AGENDA PACKET

MAY 16, 2023 MEETING

RE: John & Kristina Nelson
30 Gideon Reynolds Road
Sheet 16, Block 10533, Lot 515

PLANS REVIEWED, PREPARED BY MARCHETTI CONSULTING ENGINEERS, DATED MARCH 29, 2023:

DATE:	11.13.22
SCALE:	1" = 16'
PROJ #:	2222
DWG FILE:	2222LA
SHEET:	L1

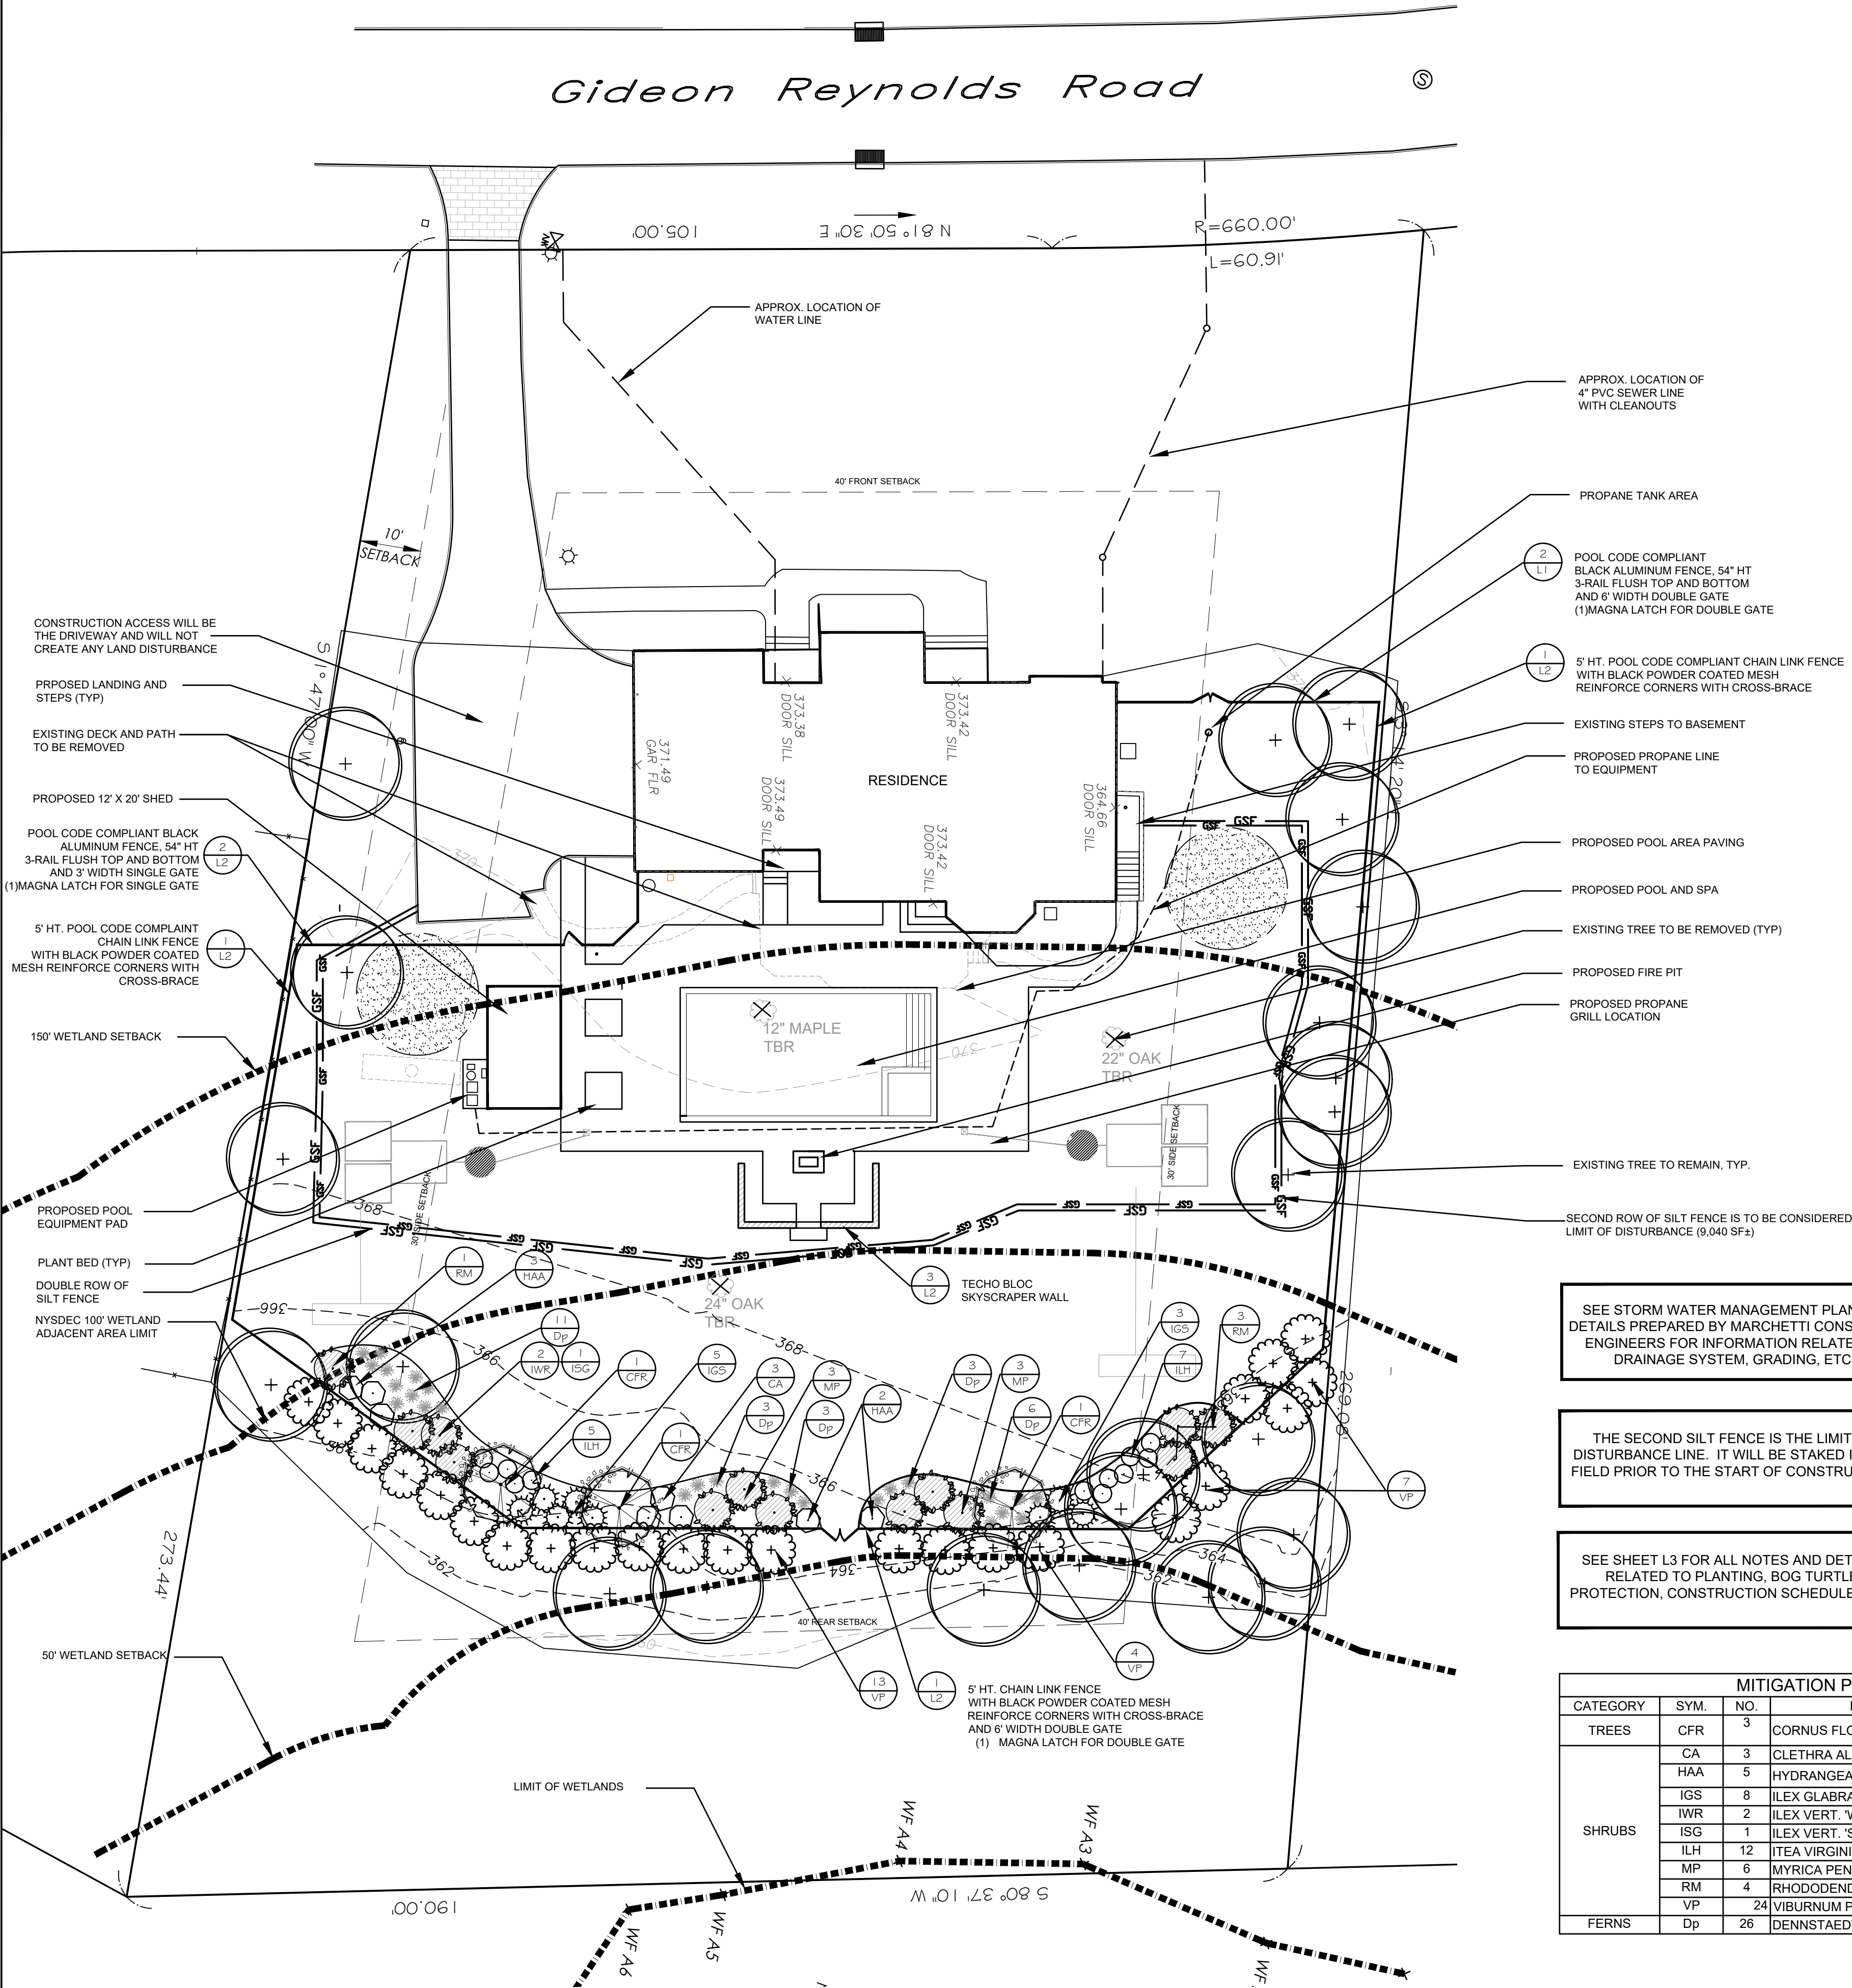
3. As previously noted, proposed grading throughout the entire development area should be illustrated on the plan, as well as spot grading on the terrace to demonstrate adequate collection of stormwater runoff. Top and bottom elevations of all proposed walls shall be identified on the plan. There does not appear to be any top and bottom wall elevations aside from a couple top wall elevations.

6. The overflow pipe associated with the eastern stormwater system needs to be connected to the units. Please correct.
7. The plan shall illustrate a stabilized construction entrance and include it in the limits of disturbance. The existing driveway will not remove silt from construction vehicles. We recommend installing

the construction entrance off the existing driveway turnaround. Provide details of the Stabilized Construction Entrance.

8. Provide details of the proposed Level Spreader.
9. The plan shall detail how the proposed shed roof stormwater will be treated. Are you proposing that the leaders connect to the proposed stormwater mitigation system?
